TO: Portland City Councilors and Robert Ganley, City Manager  
FROM: Joseph Gray, Jr., Director of Planning & Urban Development  
RE: Harborview Project - Commercial Street & Fore Street  
DATE: August 6, 1999

TO: Alan Holt, Planner  
FROM: Marge Schmuckal, Zoning Administrator  
SUBJECT: Harborview Block - B-3 Zone - PAD overlay - Historic - Old Port Overlay - 29-S-1  
DATE: July 29, 1999

# HARBORVIEW BLOCK

Site Plan Review • Portland, Maine

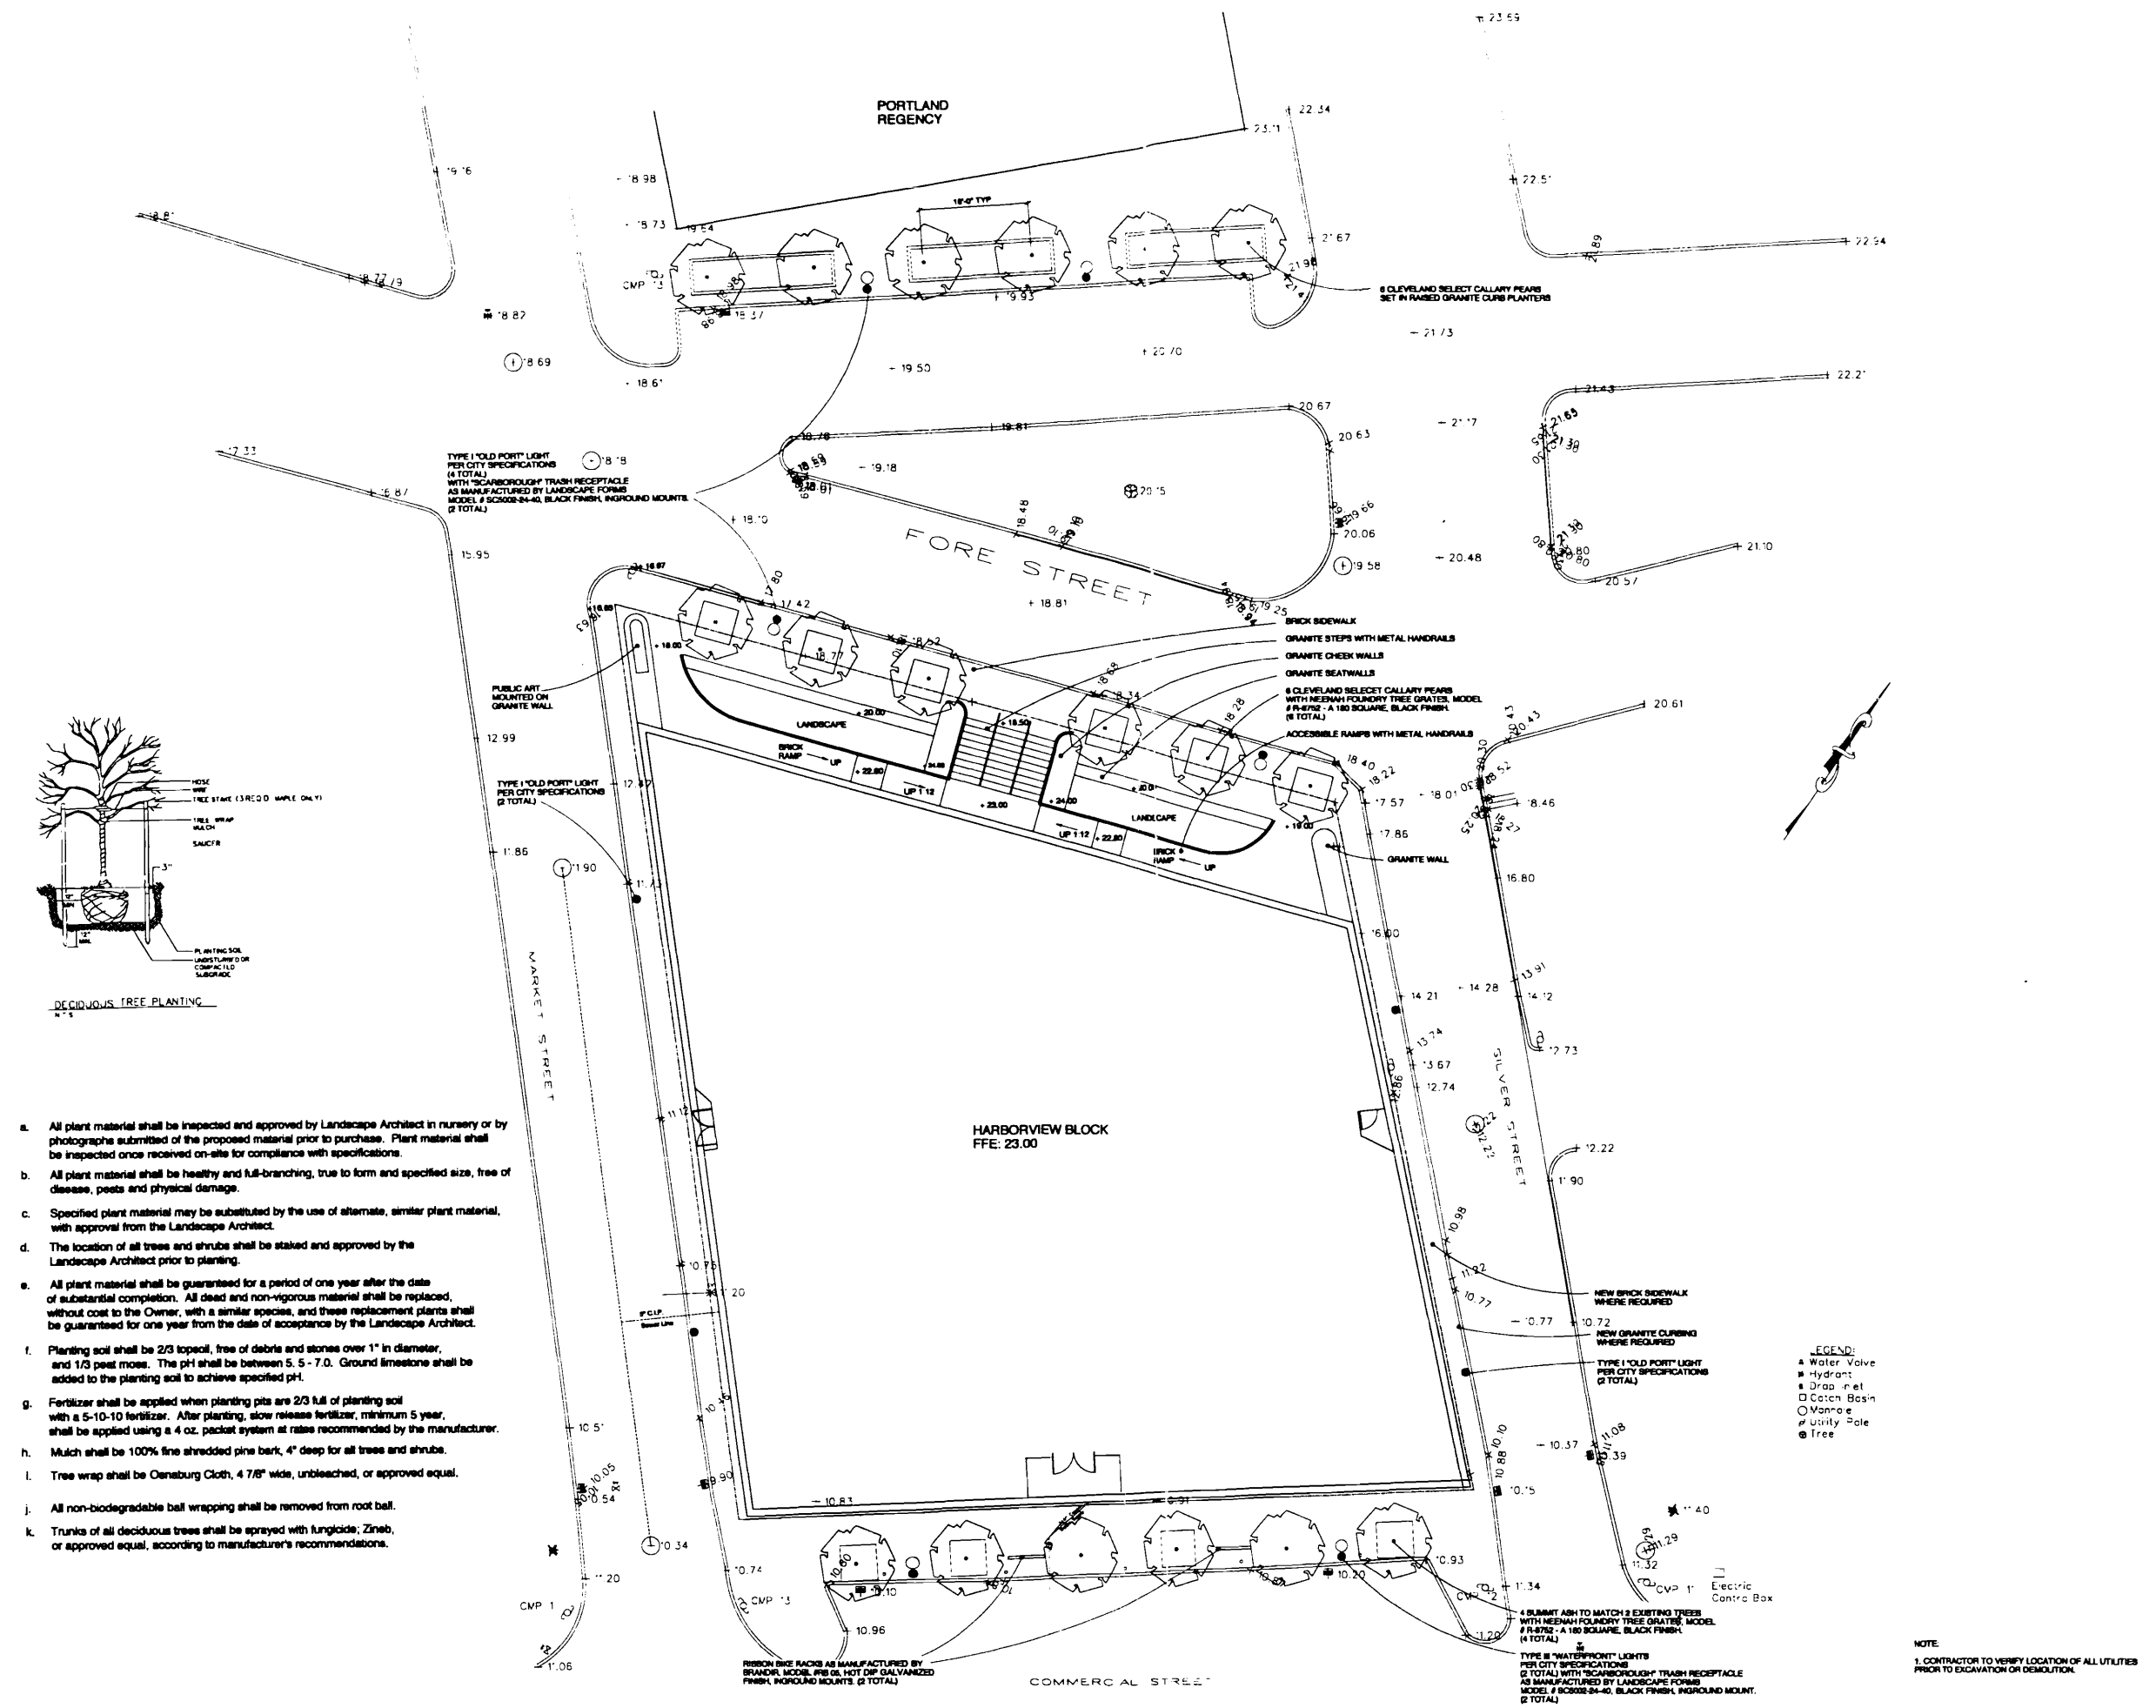
After reviewing the submittal for the proposed "Harborview Block", I am quite impressed with the project and believe that it will be a wonderful improvement and addition to that site. However, I do have a few comments concerning the letter of July 27, 1999 from Mr. Peter Hedrick, PE to Ms. Cynthia Orcutt regarding his Traffic and Parking Review. While I agree that the majority of the parking requirements for the retail spaces (excluding employees) will be satisfied by on street parking, existing garages, etc, I do not believe that the ordinance requirement of one parking space per 400 sq. ft. of office is sufficient. Therefore the developer should be required to provide over 100 off street parking spaces. Hopefully if necessary the Board of Appeals will approve the location of the parking spaces if they should be over 100' from the building.

The developers have identified a total of 320 parking spaces in three lots currently under their control of which 165 are needed for their other properties potentially leaving 155 spaces available for this project. I just think that the staff should verify that none of these spaces are already being counted for other projects. The fact that there is not a driveway servicing this building bothers me. This project will have approx. 13,500 sq. ft. of retail space. The ordinance requires one off street space of 14' x 50', for retail uses of 5 - 40,000 sq. ft. which may be somewhat excessive. Since the intent of that size space is to accommodate a tractor-trailer, truck and with the exception of moving vans we will see few of those at this site. However many retailers get very frustrated when it is difficult for them to get deliveries, or their customers have no place to park for a quick pick up. The best example of this is the shops at 2 Portland Square. Two of the retailers are constantly complaining that they receive parking tickets while parked in the No Parking Zone in front of their businesses (and they have a loading door at the rear of the building but they say it is inconvenient). Many times when vehicles are parked in a No Parking Zone traffic becomes congested and safety issues arise. To avoid future conflicts, and to attract and retain tenants I think that it would be prudent for the developer to provide an off street delivery area even if it ends up being an enclosed area only accessible via an overhead door.

Since Market and Silver streets are so narrow, there should be a five minute drop off zone at the Fore Street entrance which could be accommodated by a tear drop / indentation in the curbing. Finally, due to the size and scope of this project, I think that the developer should be required to insist that the contractor, sub-contractor and employees of the same park their vehicles off site and not tie up valuable on street spaces. During the construction of Merrill Auditorium similar language was added to the construction documents.

Lower Level Plan  
 Scale: 1" = 20'-0"  
 Date: July 12, 1999

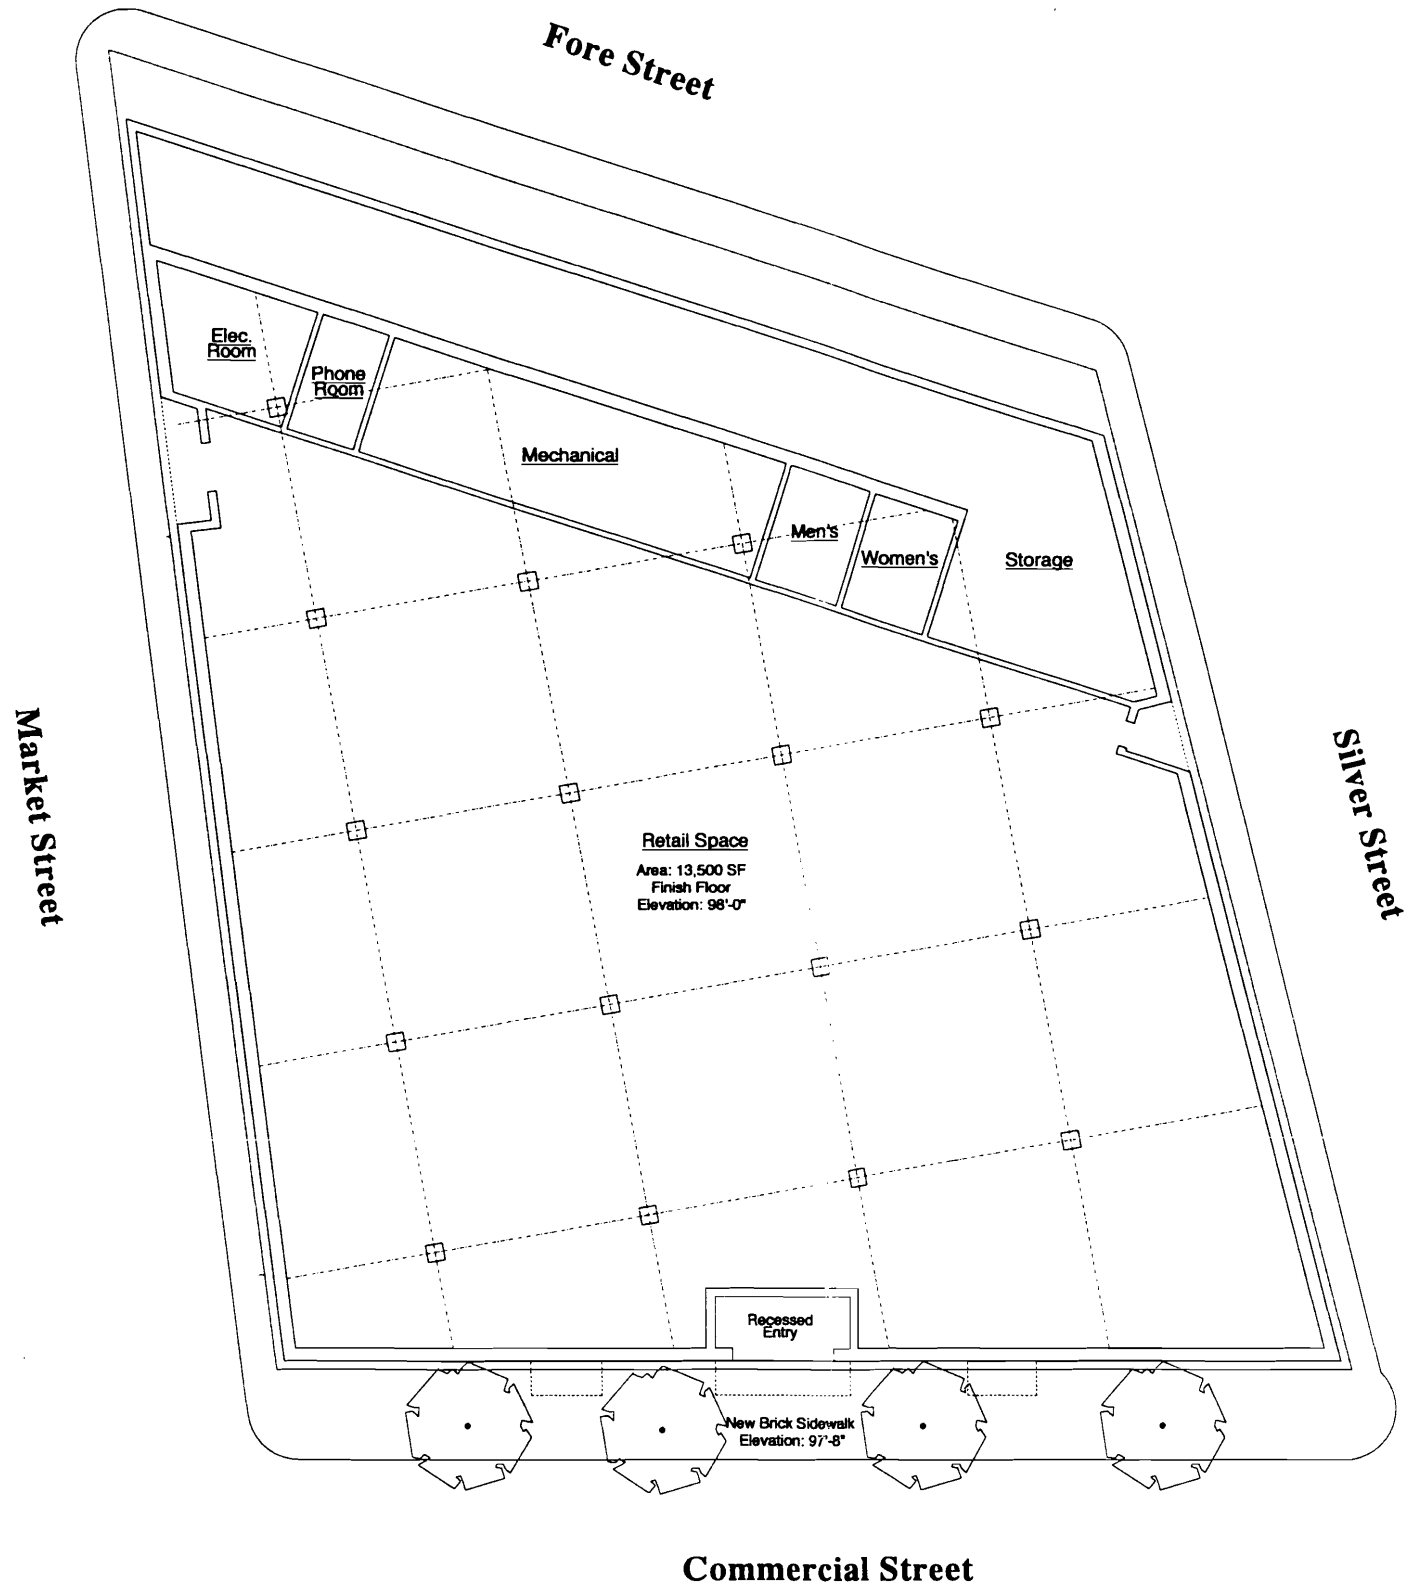
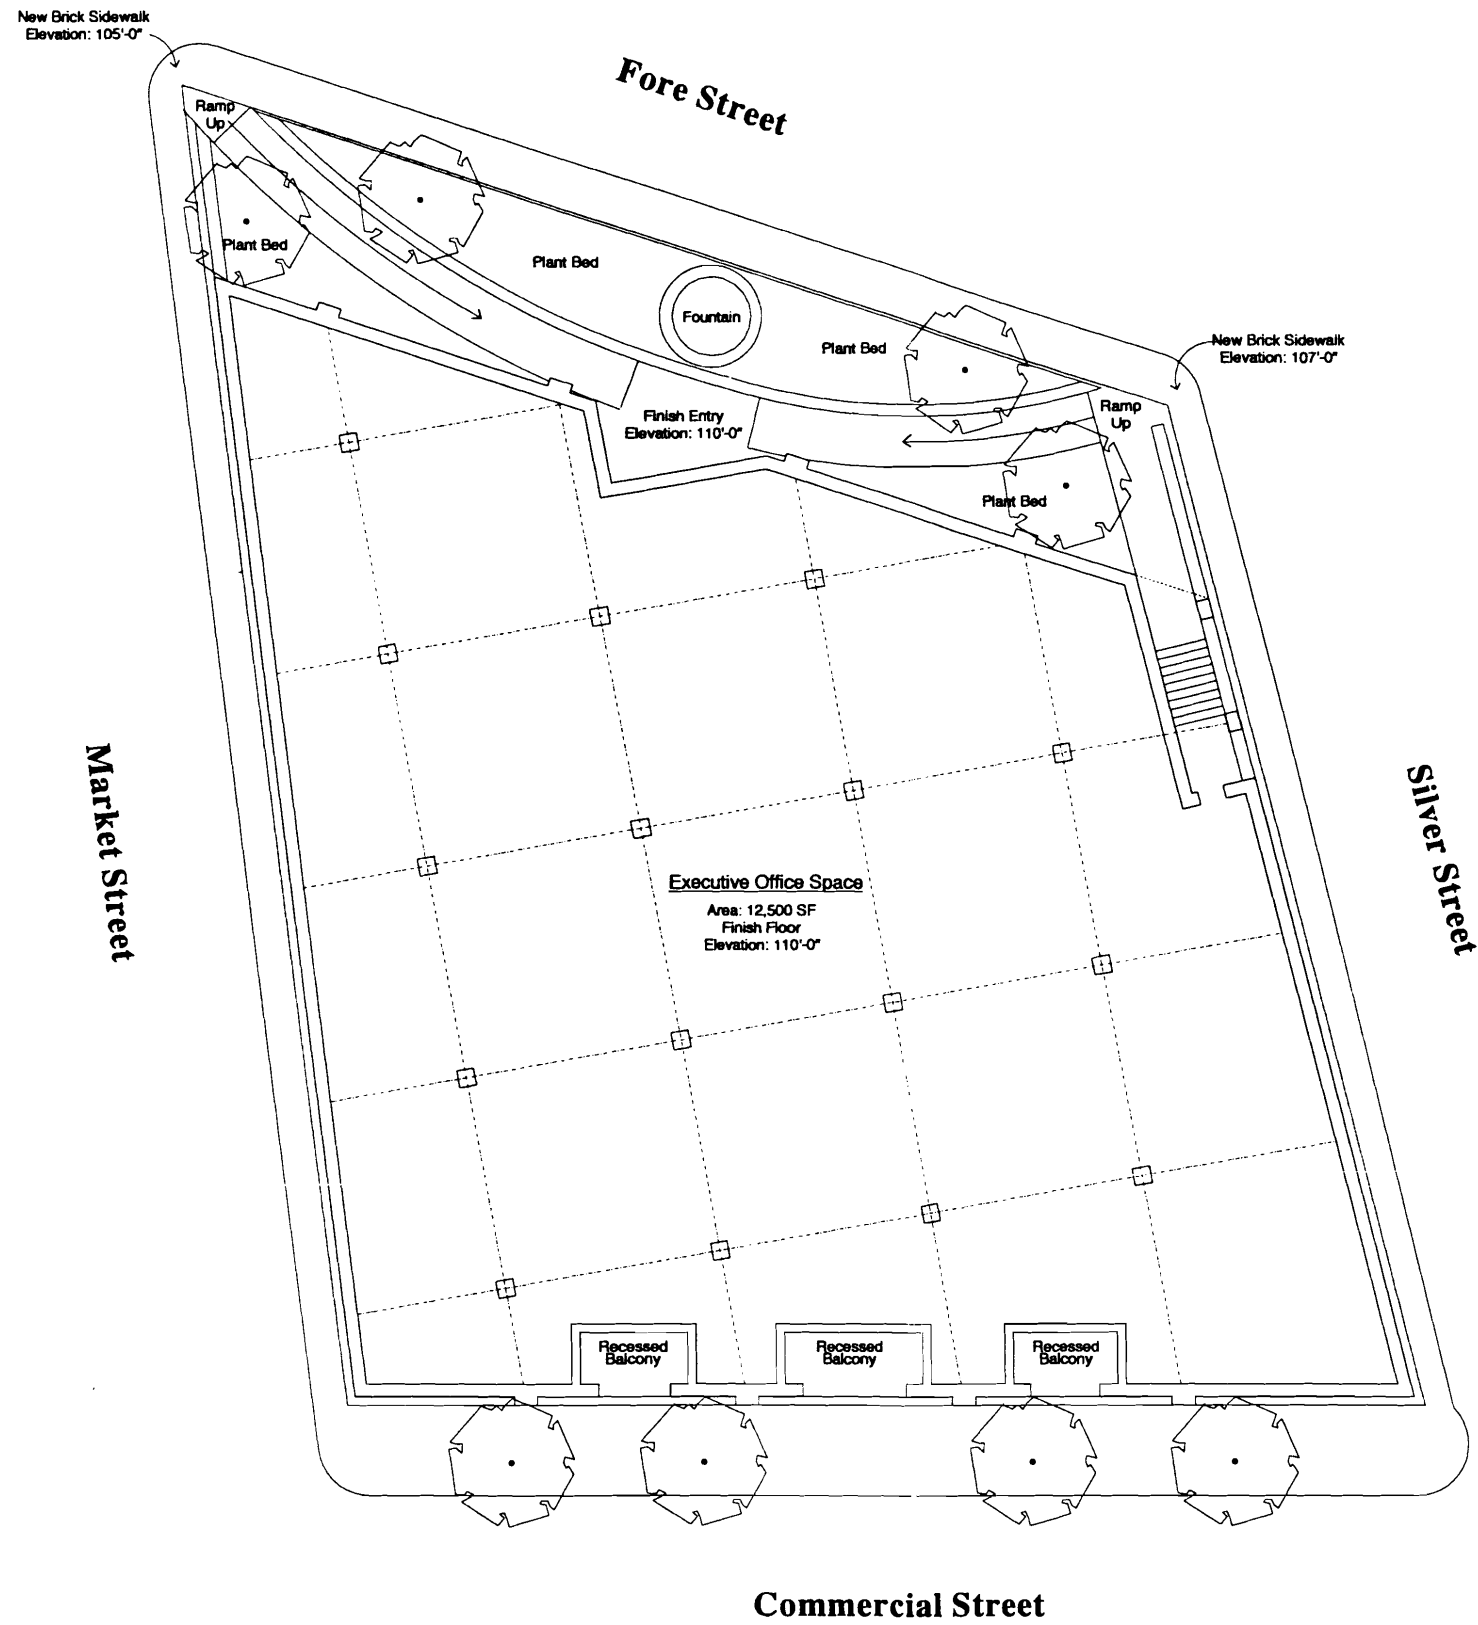
REQUEST: As soon as possible I would request floor plans so that I can confirm that PAD requirements are being met.

*would like  
A floor plan  
to verify*

Floor plans are included in this submittal.
